From: Tim McCormick <tmccormick777@gmail.com>
Sent: December 22, 2015 9:46 AM
To: Yun, Susan
Subject: Ivy Station Transit Oriented Mixed Use Development

Re: Comment on Proposed Mitigated Negative Declaration
Ivy Station Transit Oriented Mixed Use Development
Culver City File No. P2015-0141-CP, etc.

Subject: Ivy Station Transit Oriented Mixed Use Development
SCH#: 2015121083

Re: Ivy Station Transit Oriented
 Mixed Use Development
 Vic: LA-010,187/PM 4.409
 IGR#151245ME -MND

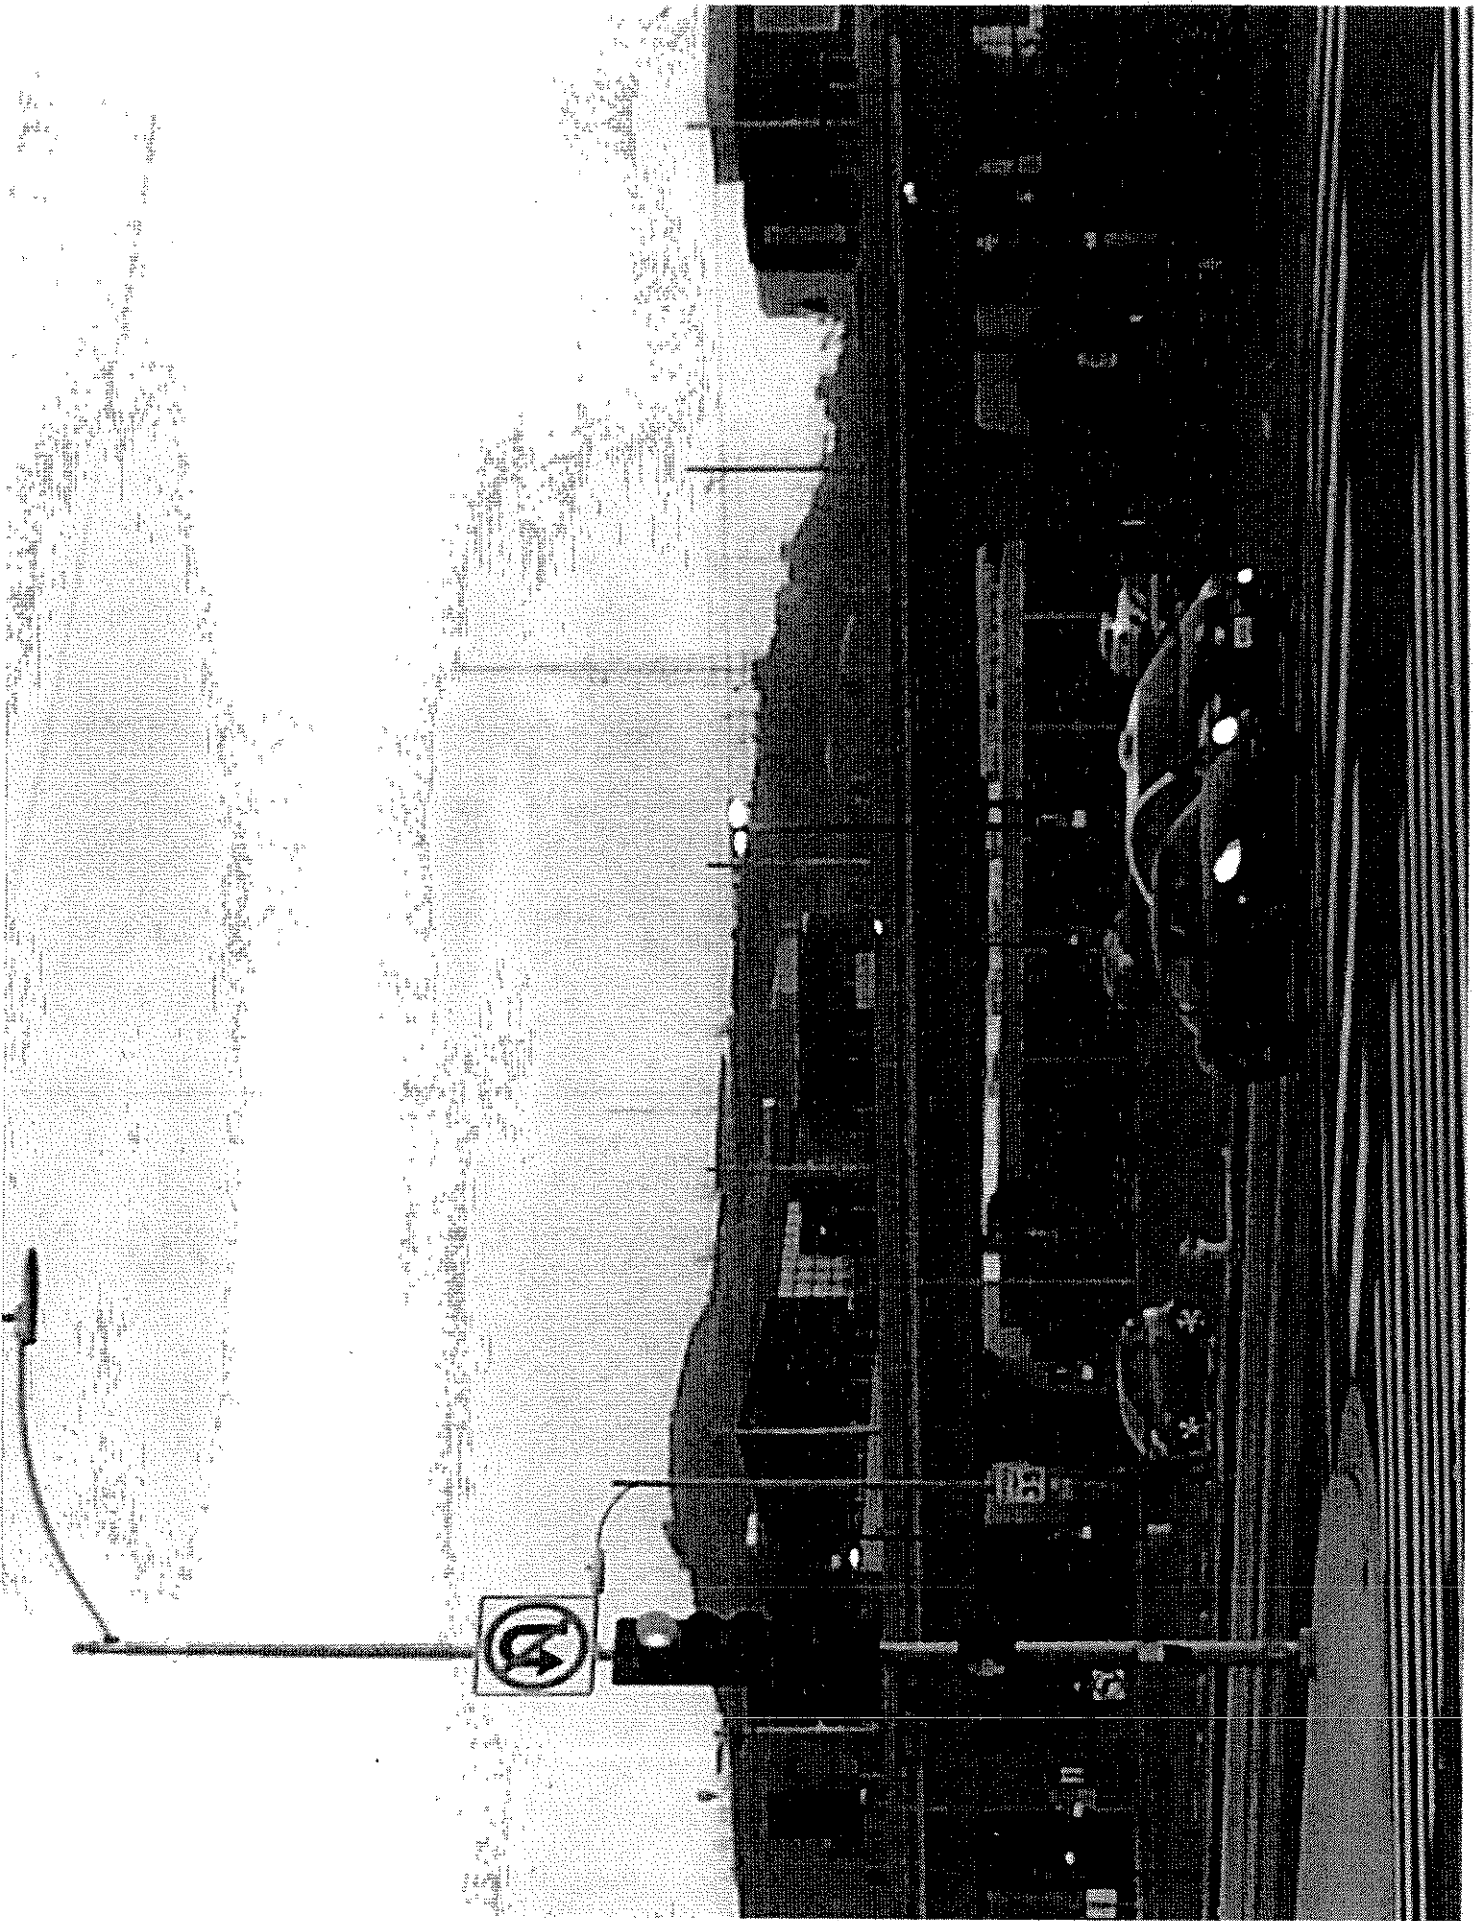
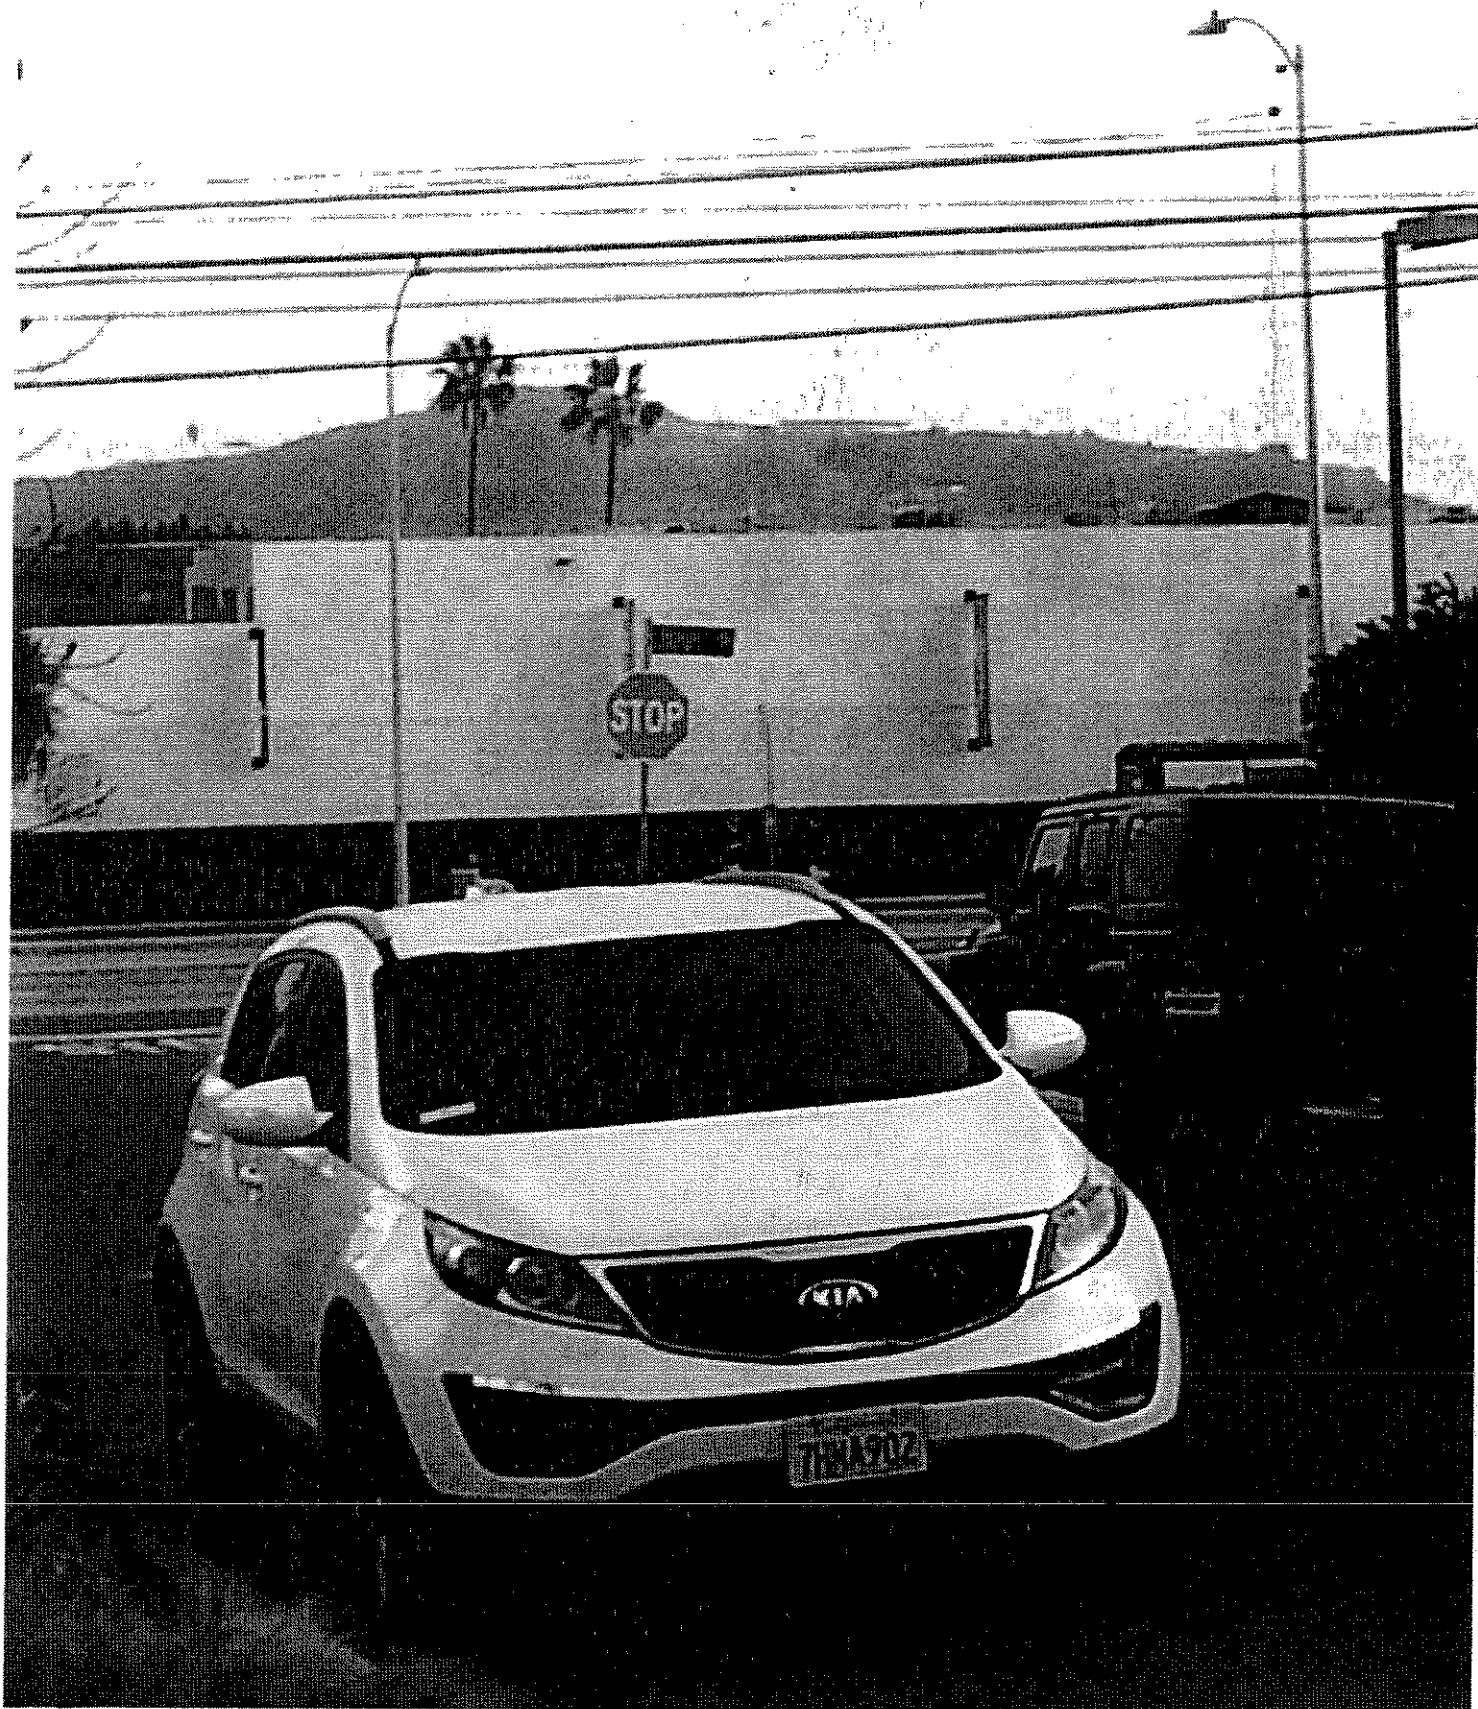
In addition, the Declaration states "While long-range views from the Metro Platform and Expo Line would be obstructed by the project's proposed structures, these City views are typical of other areas along the route with any obstruction to the field of view caused by the project being limited." This is untrue.

The typical view along the Expo line is street level, often with screens to entirely block any view at all. Only at three points on the existing route is the line above street level. Those three points are the La Brea, La Cienega, and Culver City stations. Those stations offer scenic views of the Santa Monica mountains, which include such landmarks as the Hollywood Hills, the Hollywood sign and the Griffith Park observatory. Between stations, the

line drops down to street level. Already, adjacent to the La Cienega station, development that will include one building at least 20 stories tall and multiple smaller buildings of about 80' in height have been proposed. Thus, few scenic vistas along the line exist, and fewer are expected to remain in the future. Given our local economy's significant reliance on the tourism industry, removing a rare scenic vista from a line likely to be frequently used by tourists would seem to be counter-productive.
